SERVICE LETTER 172 8750A BULKHEAD 9 CRACKING

By: MAS	Aircraft Makes/Model(s):		
Approved: DRH	Cessna 208	Float Model(s): 8750A 7000A	Note(s): Mandatory Compliance Service Letter P/N 1008990
Date: 8/14/2023	Cessna 208B		
Revision: D	Quest Kodiak 100

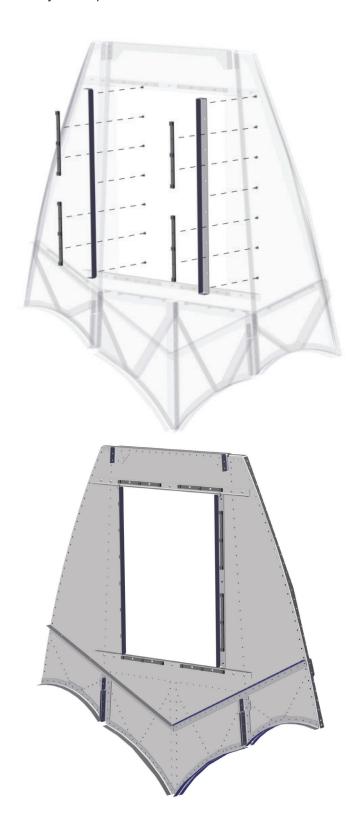
- Gain access to the bulkhead 9 assembly through the aft baggage compartment and remove 1003688 Bulkhead 9
 Access Panel. Discard (24) AN526-832R6 screws
- 2. Drill out (2) 1003690 Vertical Stiffeners

3. Inspect 1006080 Bulkhead Main Panel for cracking. If cracking is found, contact Wipaire Customer Service to receive additional instruction for repair. If no cracking is found, proceed to the next step

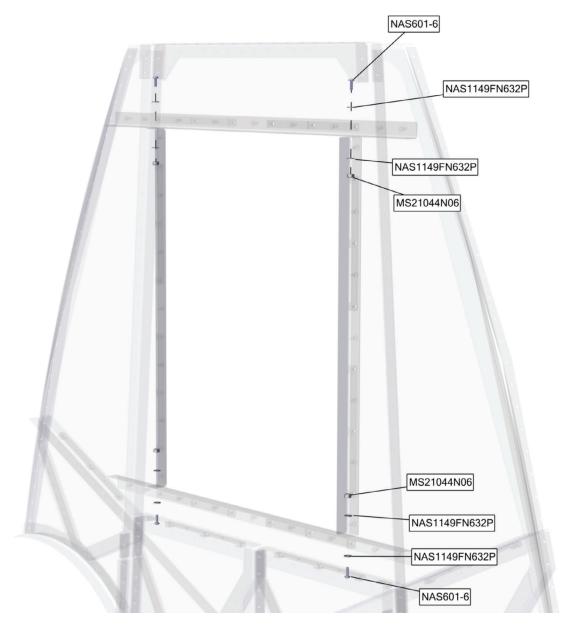
Cracking has been found on the 1006080 Bulkhead 9 Main Panel. The 1003690 Vertical Stiffeners have been revised to include a flange that will be riveted to the Horizontal Stiffeners for additional support

4. Position (2) revised 1003690 Vertical Stiffeners and (4) new 1011055 Nylon Nutplates where shown. Cleco in position and rivet Vertical Stiffeners and Nylon Nutplates to 1006080 Bulkhead 9 Main Panel.

5. Backdrill through the 1003689 Horizontal Stiffeners in the 4 locations shown using a #27 drill bit.

6. Install (4) NAS601-6 screws, (4) MS21044N06 nuts, and (8) NAS1149FN632P washers attaching the flange of each 1003690 Vertical Stiffener to the 1003689 Horizontal Stiffeners as shown.

NOTE: Rivets may be used in place of the hardware if desired.
